**REVISION II
TO
VOLUME IV OF IV REPLACEMENT
AMENDMENT TO FINAL CLOSURE PLAN
LOPEZ CANYON SANITARY LANDFILL
LAKEVIEW TERRACE, CALIFORNIA**

**LOPEZ CANYON LANDFILL- SUBMITTAL OF REVISION 2 TO VOLUME IV OF IV
REPLACEMENT OF AMENDMENT TO THE FINAL CLOSURE PLAN**

**SUMMARY TABLE OF REVISIONS TO
VOLUME IV OF IV REPLACEMENT AMENDMENT TO
FINAL CLOSURE PLAN
Revised October 1998**

FIGURE NO.	2-3(a)
PROJECT NO.	CE4100-04
DATE:	30 JUNE 1998

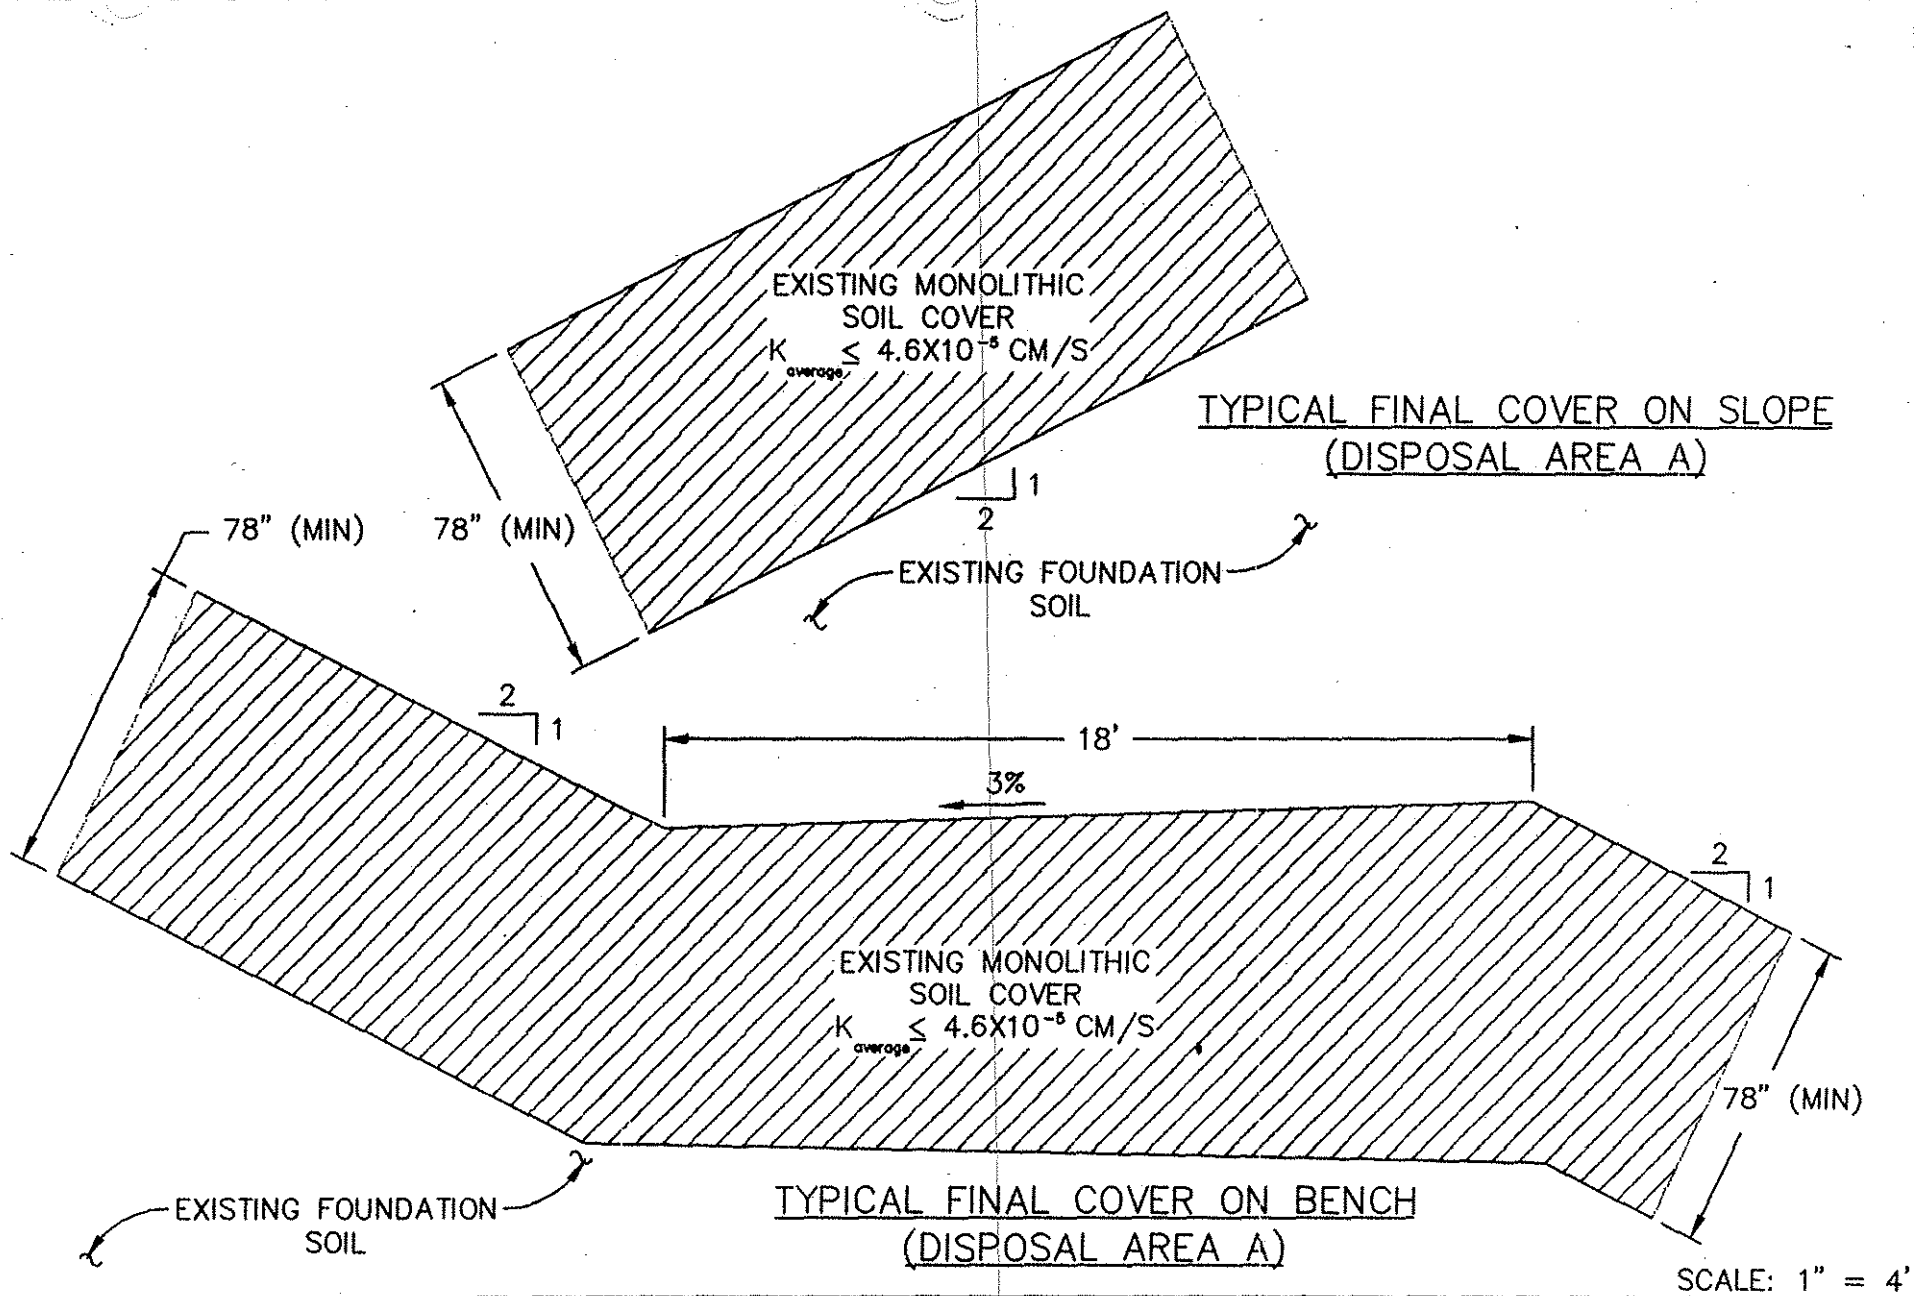
Tables	Add Table 2-3 Replace Table 9-1	Monolithic Soil Cover Testing Summary Revised Summary of Closure Cost Estimate
Figures	Add Fig. 2-0 Replace Fig. 2-2 Delete Fig. 2-2(a) Delete Fig. 2-2(b) Add Fig 2-2(a) Add Fig 2-2(b) Delete Fig. 2-2(c) Delete Fig. 2-2(d) Replace Fig. 2-3 Replace Fig. 2-3(a) Replace Fig. 2-3(b) Replace Fig. 2-4 Replace Fig. 10-1	Landfill Final Cover Configuration Final Cover on B Deck GCL on A, B and AB+ Decks GCL on A, B, AB+ and C Decks Final Cover on A and AB+ Decks Vertical well on A, B, AB+ Decks Vert. Well on A, B, AB+ Decks – prescriptive Vert. Well on A, B, AB+ Decks – GCL Final Cover on Slopes/Benches of B Canyon Final Cover on Slopes/Benches of A Canyon Final Cover on Slopes/Benches of AB+ Cny. Final Cover System under Haul Road Revised Closure Schedule
Appendix F: "Updated Closure and Post-Closure Cost Estimates"	Replace in Entirety	Reflects cost revisions pertaining to use of a monolithic cover
